SUBJECT: Forwards response to Phase II of NUREG-0612, "Control of Heavy Loads at Nuclear Power Plants." Items discussed include stop plugs, vessel cavity plugs, dryer, separator pool stop plugs, fueling stop plugs & auxiliary hoist.

Subject: NUCLEAR PROJECT NO. 2
RESPONSE TO NUREG-0612 - PHASE II
CONTROL OF HEAVY LOADS; SUBMITTAL OF

Supply System Response to Report:
"Control of Heavy Loads at Nuclear Power Plants"
Washington Nuclear Project No. 2
(Phase II - Interim)
Docket No. 50-397

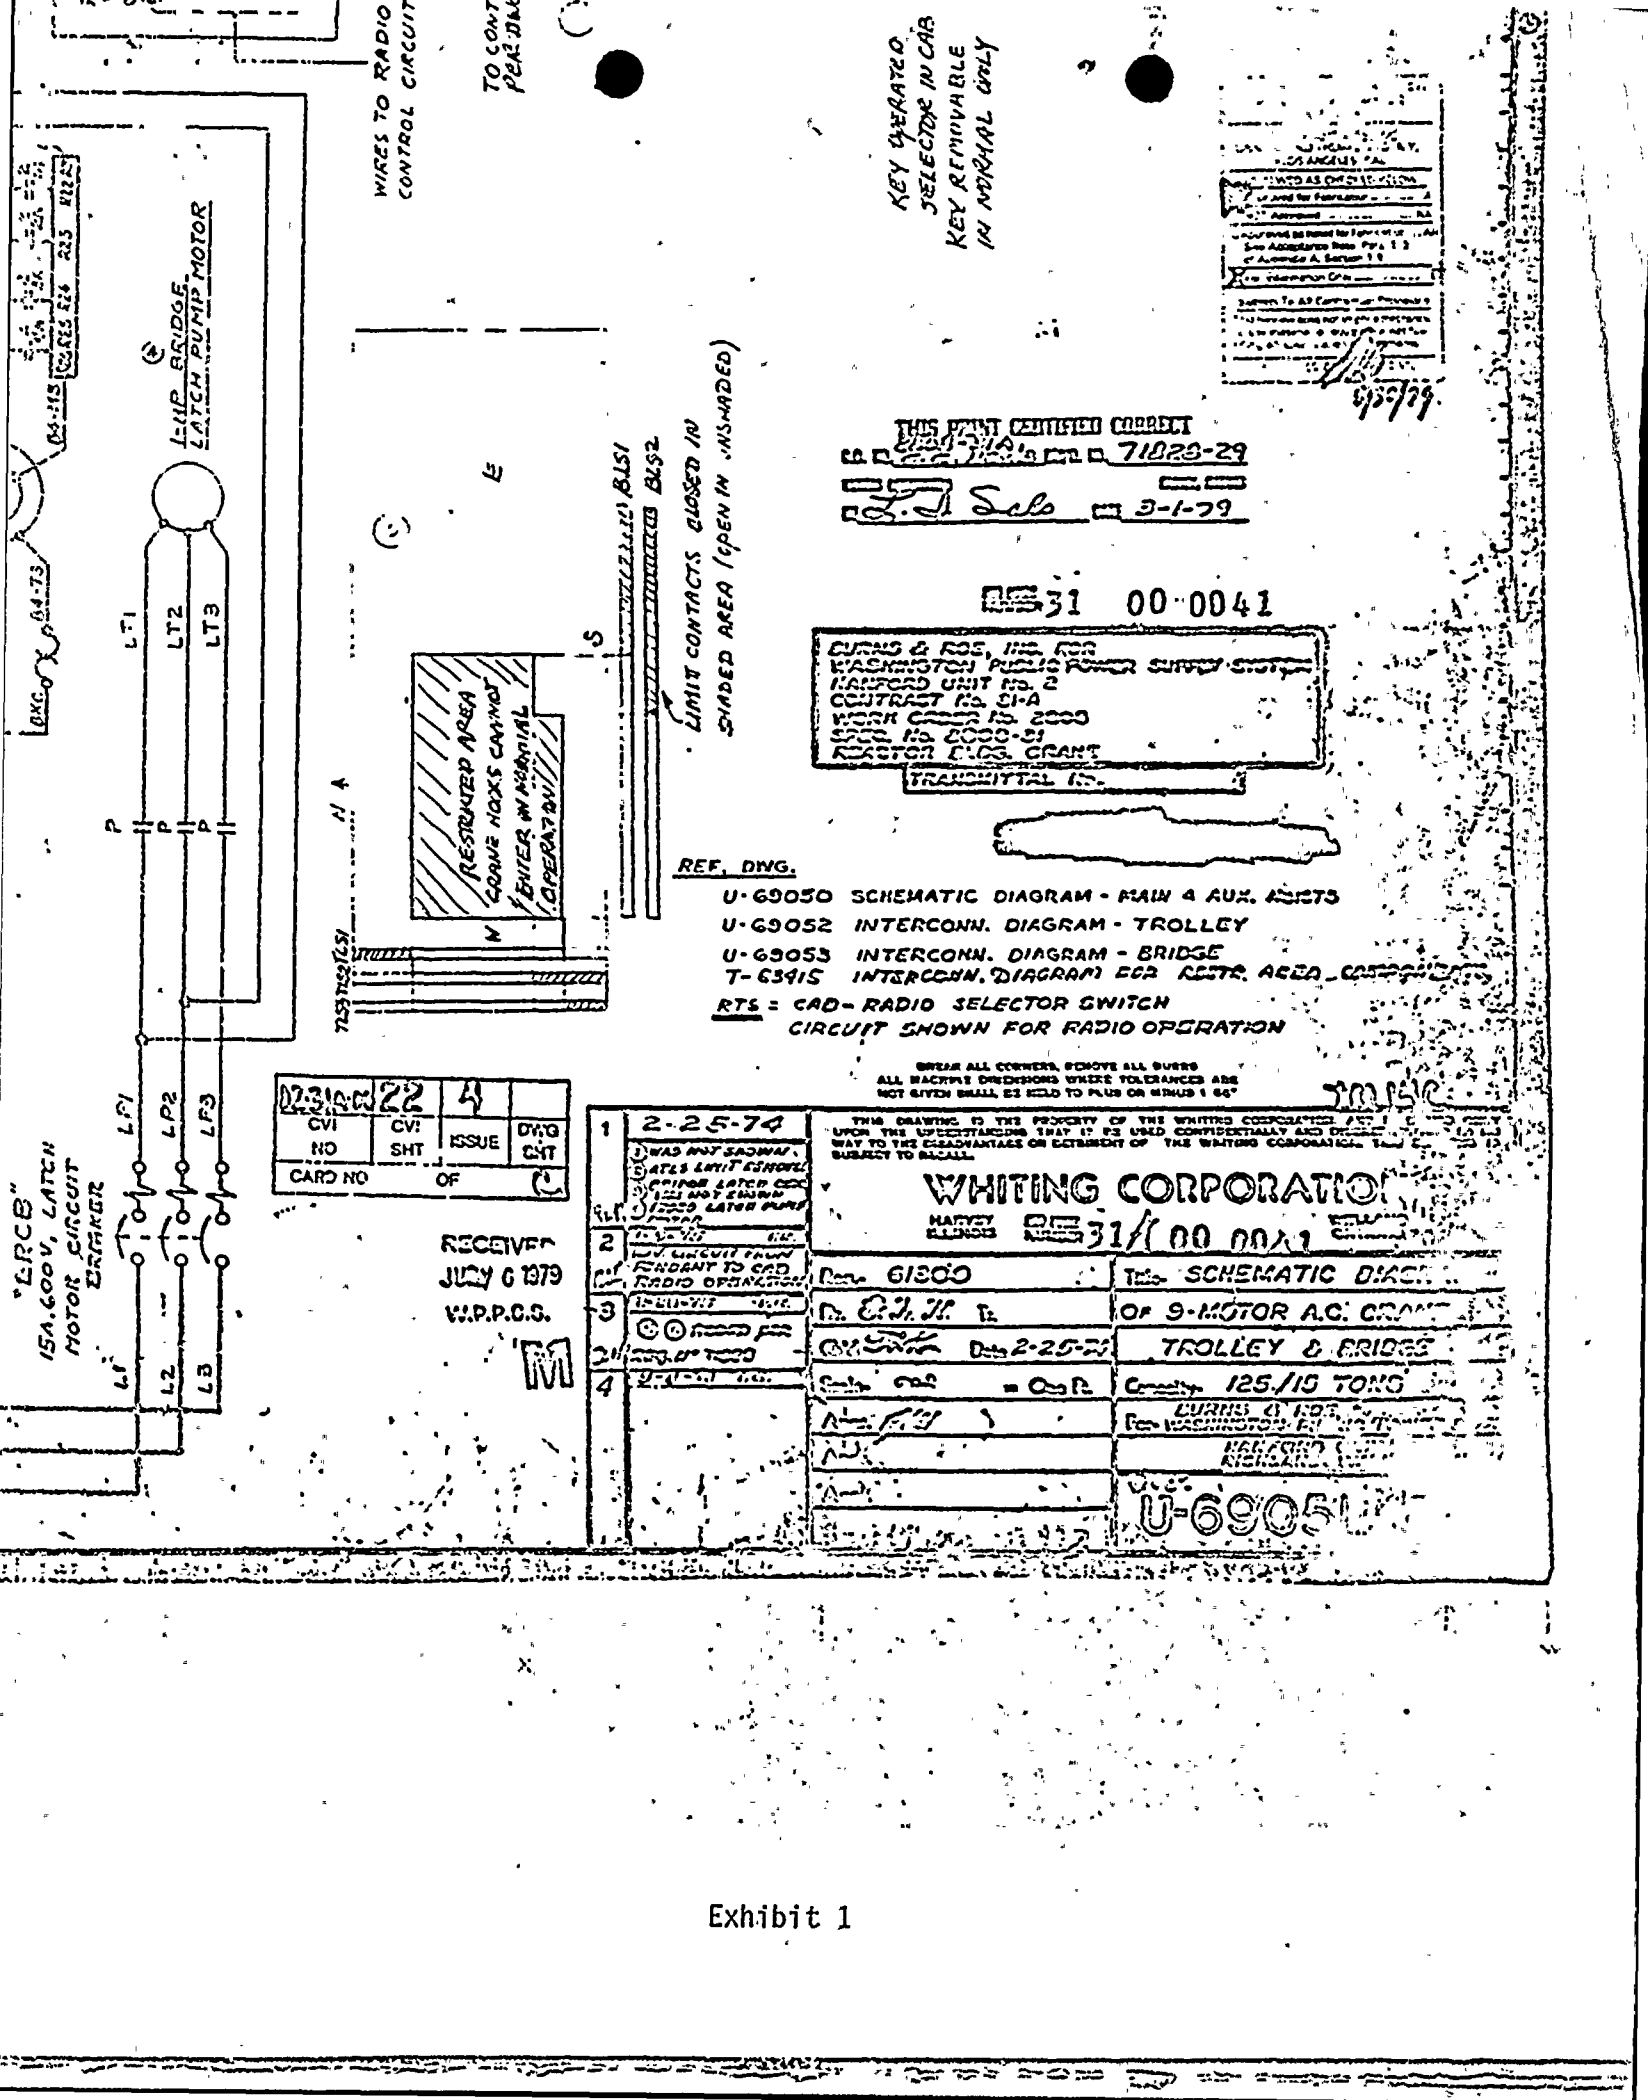
"The applicant should provide more information on the method of travel limitation for the MT-CRA-2 hoists over the fuel storage pool."

The Reactor Building crane travel and hoisting systems are totally stopped (de-energized) through an array of bridge and trolley track mounted limit switches when the crane trolley (main hook centerline) comes within 6' of the north, south and west side and within 2' of the east side of the spent fuel pool - except directly over the cask handling area. Electrically the schematic for the limit switches and relay interlocks are shown on Whiting Crane drawings

U-69050 and U-69051. Exhibit 1 shows a relevant part of these drawings. The ability of these interlocks to function is tested on surveillance test 7.4.9.6 which states "Interlocks shall be demonstrated operable within 7 days prior to use and at least once per 7 days during crane operation."

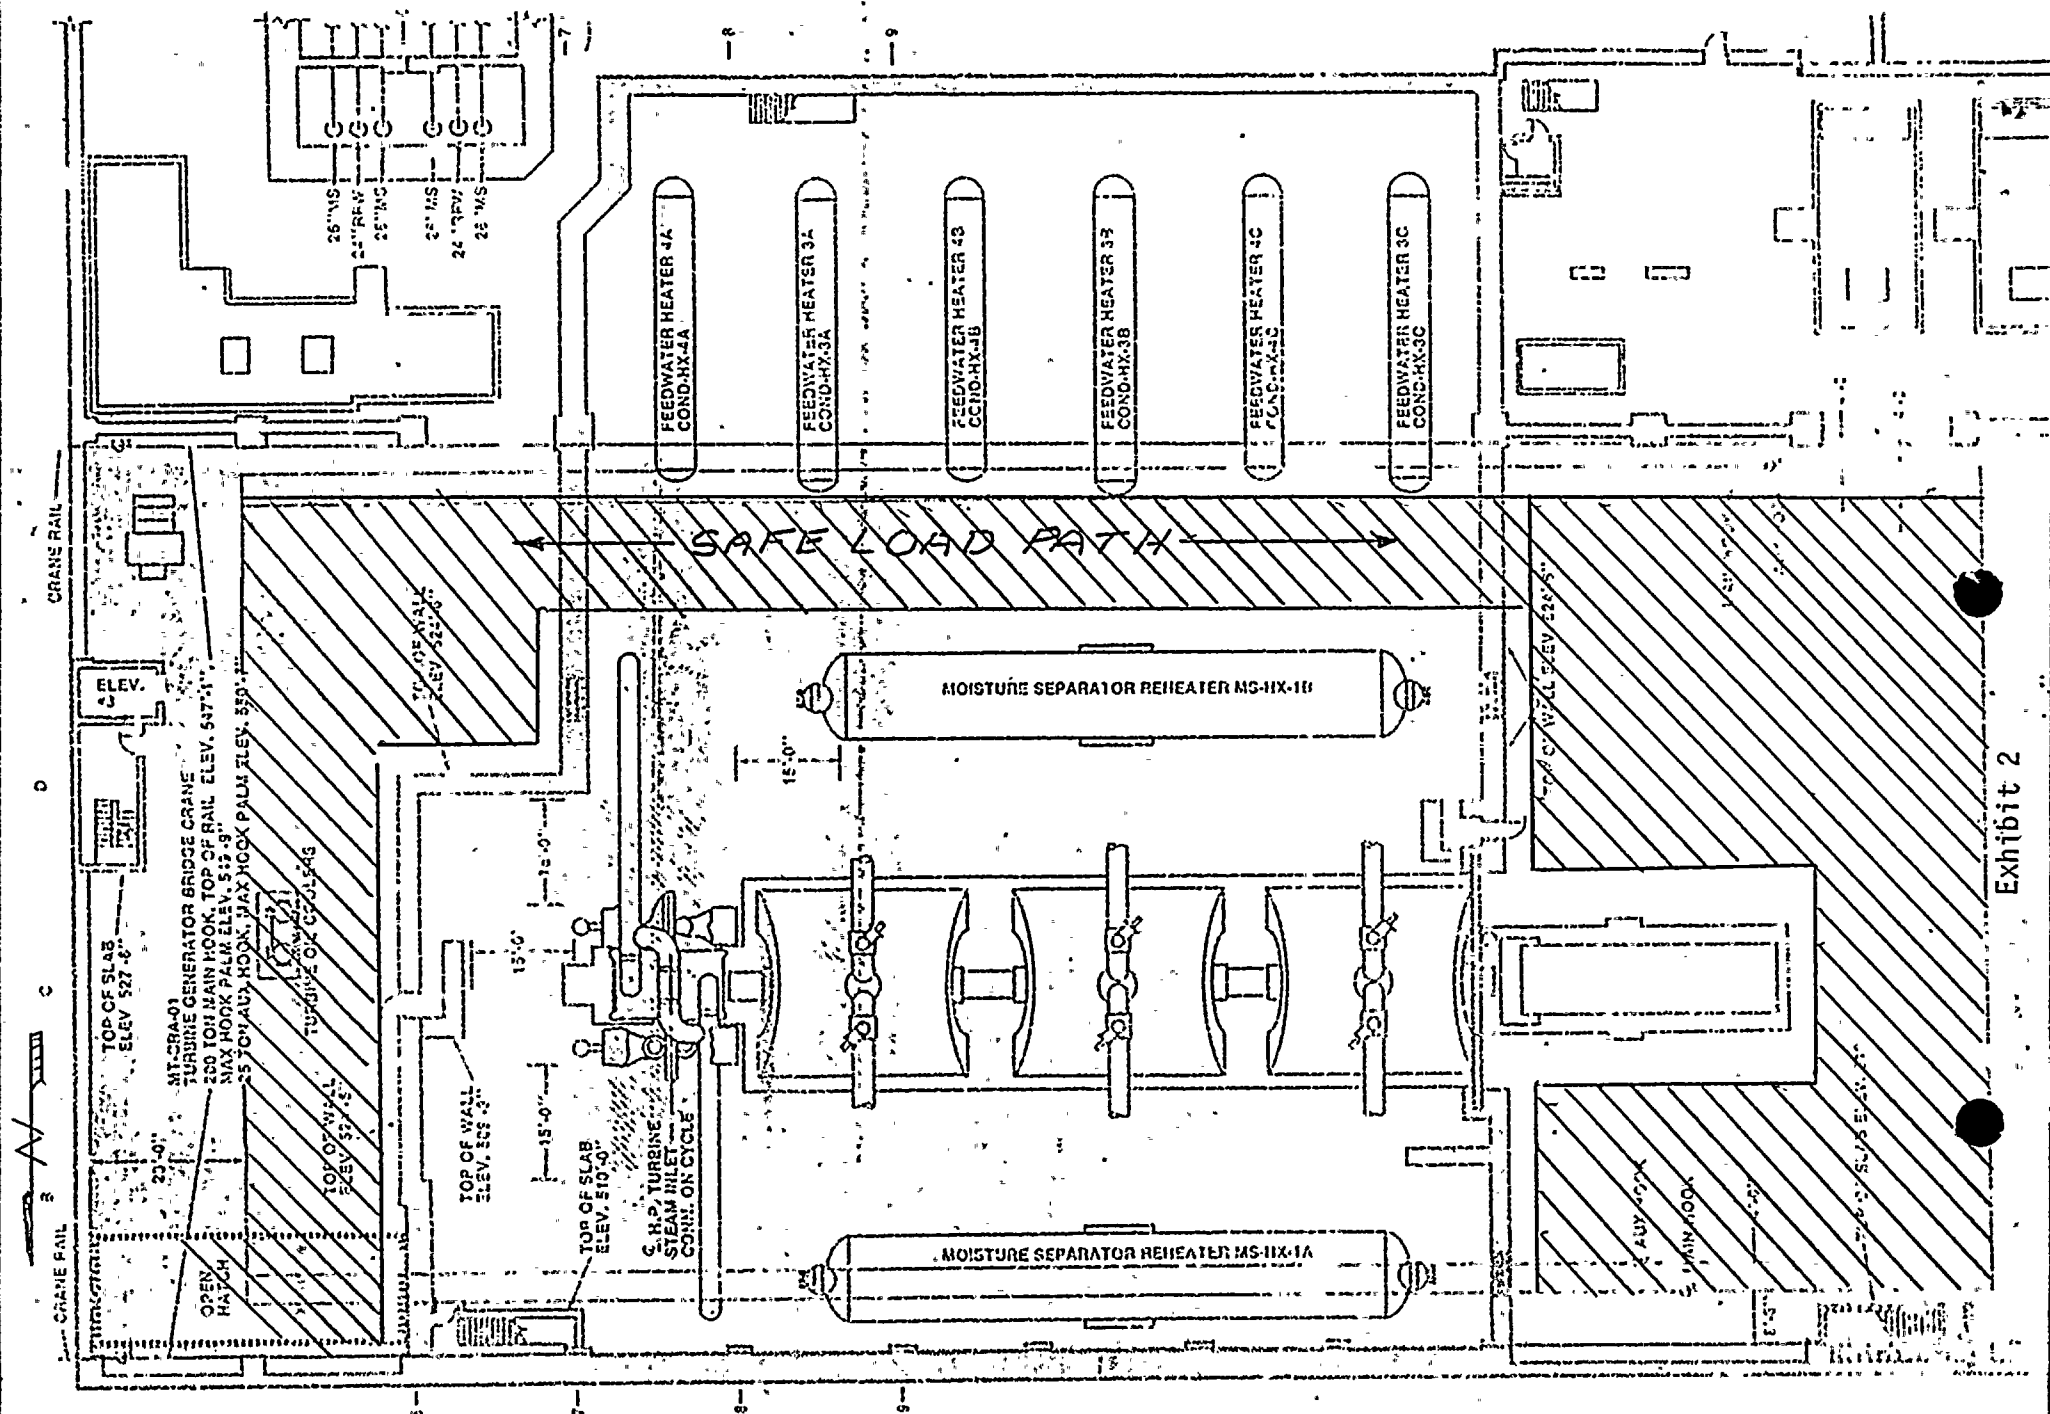
"The applicant has not addressed the Turbine Building Travelling Bridge Crane MT-CRA-1."

The Turbine Building crane does not conform to the single-failure-proof guideline of section 5.1.6 of NUREG-0612. As previously committed a procedure has been prepared (PPM-10.17.5) which established a safe load path for this crane during plant operation. A copy of the safe load path is attached as exhibit 2 to this response.

Loads will be carried well below the shield wall - approximately 5' off the 501 floor level during north-south travel and raised up over the shield walls during east-west travel. During much of the east-west travel, the turbine is "sheltered" by the moisture separator-reheater. The safe shutdown equipment that could be affected by a dropped load over the high pressure turbine are 1) the stop and throttle valve limit switches whose contacts open up when the valve closes 10% from the full open position. This opening de-energizes relays which, when coupled with the closure of one other valve in a second loop, will result in a reactor shutdown and 2) the governor valve fast closure switches which, on a rapid loss of DEH hydraulic fluid pressure on one valve in each loop, combine to shut the reactor down.
